HaskoningDHV Vietnam Co. Ltd.
Water

To: Quang Nam PPMU; TEDIPORT Consultant
From: Huy Hoang
Date: 15/03/2021
Copy: World Bank; RVO
Our reference: VN2243-RHD-ZZ-XX-NT-Z-0001
Classification: Project related
Checked by: Karel Heijnert

Subject: Review of Hydrology and Hydraulic Modelling Report (2019)

Figure 1: Hydropower dams on VGTB river basin (Source: <http://avuong.com>)

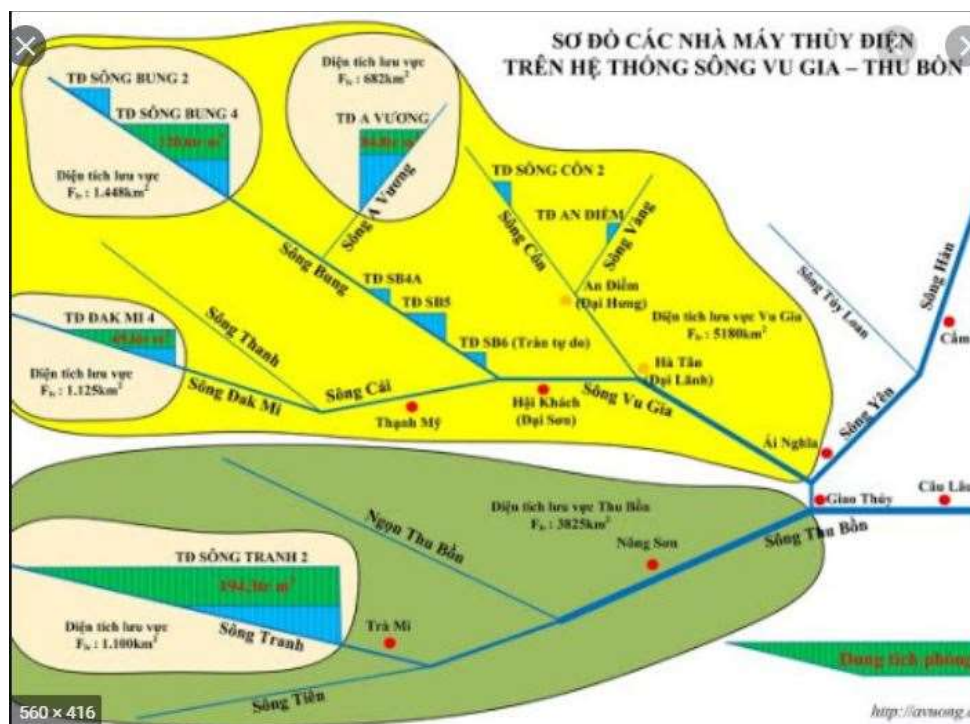
Several hydropower reservoirs in the upstream of VGTB rivers and the Phu Ninh irrigation reservoir were not taken into account in the simulation of the hydraulic model MIKE 11. The current flows in Nong Son and Thanh My stations are not natural flows. These flows are influenced by the upstream reservoirs such as Song Tranh 2, 3, 4 (from 2010) and Dak Mi 4 reservoirs (from 2012). Therefore, the model simulations for high flow conditions, based on the historical data of Nong Son and Thanh My, do not provide realistic flood levels, extents and frequencies. They are most likely overestimated. These means that the current results of the simulations of flood levels and extents should be considered with great care, as they are likely overestimations.

- The upstream model boundaries should be extended to Song Tranh 4 and Dak Mi 4, and Song Bung tributary (from Song Bung 5 or Song Bung 6 reservoir) should be added to the schematisation
- The operation procedures of the VGTB hydropower dams and Phu Ninh reservoirs should be considered in the MIKE 11 model. Moreover, the water diversion (Ex. Dak Mi 4) should be also included in the simulation in the dry season.

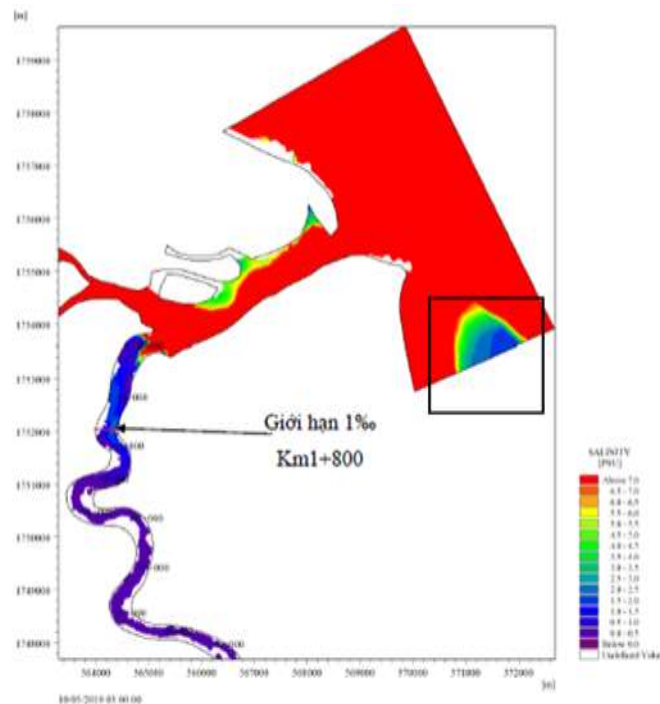
- *Upstream boundaries.* It is recommended to use the boundaries at downstream locations of Song Tranh 4, Dak Mi 4, Song Bung 6 and Phu Ninh reservoirs. The observed outflows of these reservoirs could be used for the inputs of model calibration process. The operation procedures of the upstream reservoirs should be used in the scenario simulations.

- *Number stations used for calibration.* Currently, the model is calibrated and validated with water level and discharge data at 3 monitoring stations (Hoi Khach, Ai Nghia, Giao Thuy). It is suggested to also calibrate with other stations such as Cau Lau, Vinh Dien, Hoi An, Cam Le, Tam Ky (and Nong Son, Thanh My if the model is extended). The observed discharge data for these stations should then be collected and used for further model calibration and validation.

- *Calibration and validation periods.* The model is calibrated and validated with the flood events in the years 1996, 1998, 1999, 2004 and 2007. It is suggested to calibrate and validate some flood events in the last 5 years when almost hydropower dams have operated.
